Independent Assessment Report

Section 4.56 Application: 12A and 14-26 Wattle Street, Pyrmont - D/2019/649/B**File No.:** D/2019/649/B**Summary**

Figure 53: Assessment of compliance with ADG Objective 3F-1 separation distances (Sections AA, BB, CC and DD) (non-compliances highlighted)

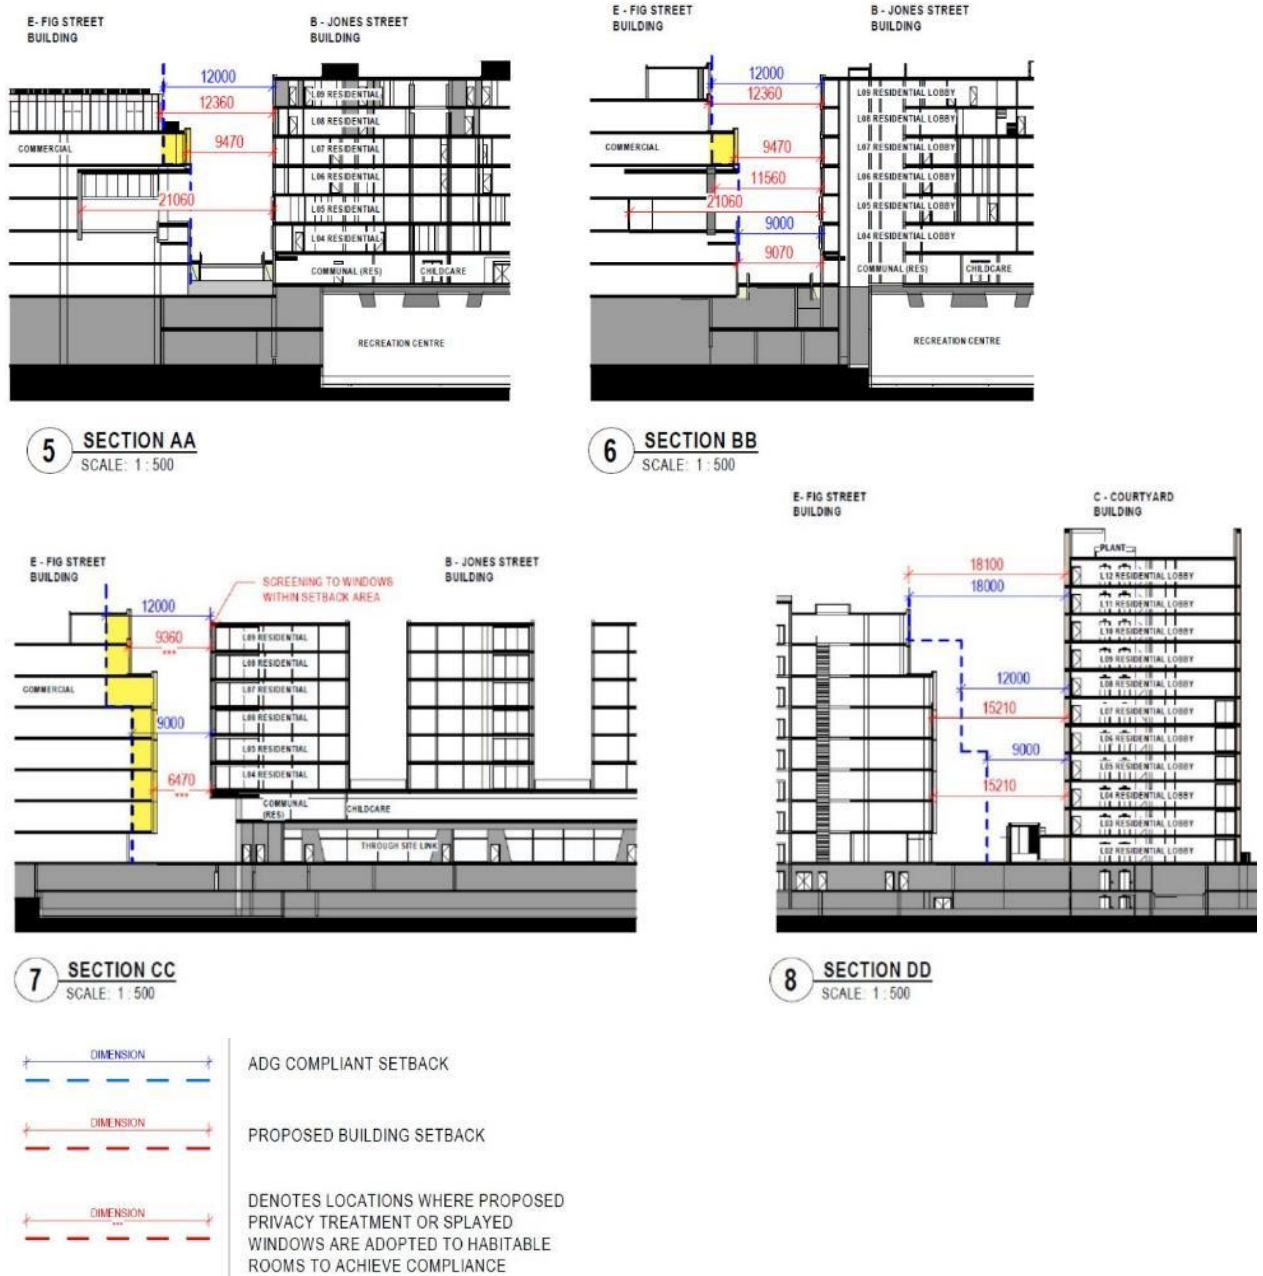
56. The building envelopes proposed by the section 4.56 modification application do not fully achieve these separation distances. The sections at **Figures 53 to 55** illustrate where the proposed envelopes do not achieve the ADG separation distances (the diagrams were prepared by BVN and are included in concurrently lodged development application). Non-compliances occur between the following buildings:

- (a) Building B - Jones Street/Building F - Fig Street (see **Figure 53**, Sections AA, BB and CC)
- (b) Building D - Wattle Street/ Building F - Fig Street (see **Figure 54**, Section EE, FF and GG)
- (c) Building C - Courtyard/Building B - Jones Street (see **Figure 55**, Section HH)
- (d) Building C - Courtyard/Building D - Wattle Street (see **Figure 56**, Section HH)

58. The non-compliances subject to the notation on the building envelope plans are considered to be satisfactory and capable of achieving reasonable levels of external and internal privacy (the mitigation measure notation is also generally consistent with the approved building envelope plans which include a similar notation where ADG separation distances are not achieved). The detailed design development application demonstrates that daylight and natural ventilation are not compromised by the building separation non-compliances.
